# Access Compliance Report

## Public Rights-of-Way

### (Curb Ramps)

Intersection ID: 47966	Main Street: MESA_VERDE_RD	Cross Street: TOM_SHORT_RD	Location: SE
ADA ID: 097D0DBC5F25	Ramp Type: PerpDiag	Initial Pass/Fail: Fail	Overall Compliance: No
		Severity Score: 10

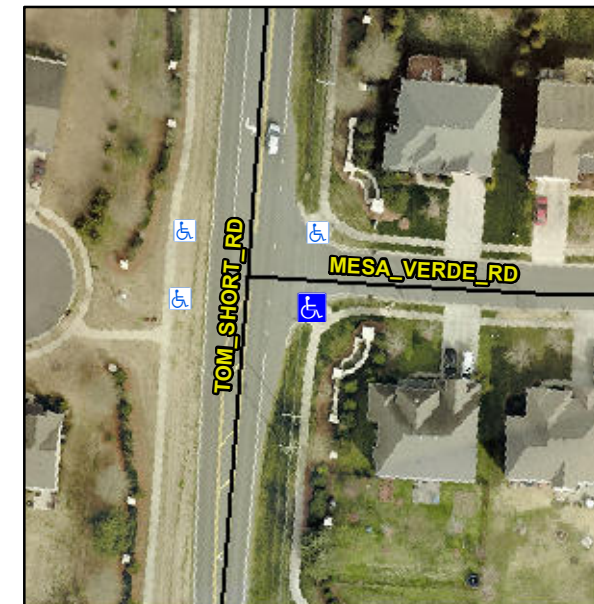
**Not Found, R304.5.1, R304.5.3**

Compliance	Description	Data	Compliance	Description	Data
N/A	Ramp Length (in)	153.0	Yes	Ramp Slope (%)	5.0
No	Ramp Width (in)	44.0	No	Ramp XSlope (%)	3.5
N/A	Flare Type LT	N/A	N/A	Flare Type RT	N/A
N/A	Flare Slope LT (%)	N/A	N/A	Flare Slope RT (%)	N/A
N/A	Flare Traversable LT?	N/A	N/A	Flare Traversable RT?	N/A
N/A	Landing Length (in)	N/A	N/A	DWS Provided?	N/A
N/A	Landing Width (in)	N/A	N/A	DWS Contrast?	N/A
N/A	Landing Slope (%)	N/A	N/A	DWS Length (in)	N/A
N/A	Landing X Slope (%)	N/A	N/A	DWS Full Width?	N/A
N/A	Landing Curb? (Y/N)	N/A	N/A	DWS Offset (in)	N/A
N/A	Shared Landing?	N/A			
N/A	Gutter Ponding?	N/A	N/A	Gutter Slope (%)	N/A
N/A	Gutter Lip Ht (in)	N/A	N/A	Gutter X Slope (%)	N/A
N/A	Painted X Walk1?	No	N/A	Painted X Walk2?	No
	X Walk 1 Direction	To NE		X Walk 2 Direction	To NW
N/A	X Walk 1 Width (in)	N/A	N/A	X Walk 2 Width (in)	N/A
	X Walk 1 Slope (%)	2.7		X Walk 2 Slope (%)	3.0
	X Walk 1 X Slope (%)	3.7		X Walk 2 X Slope (%)	3.0

**Remove & Replace Curb Ramp With Two New Directional Ramps or Equivalent.**
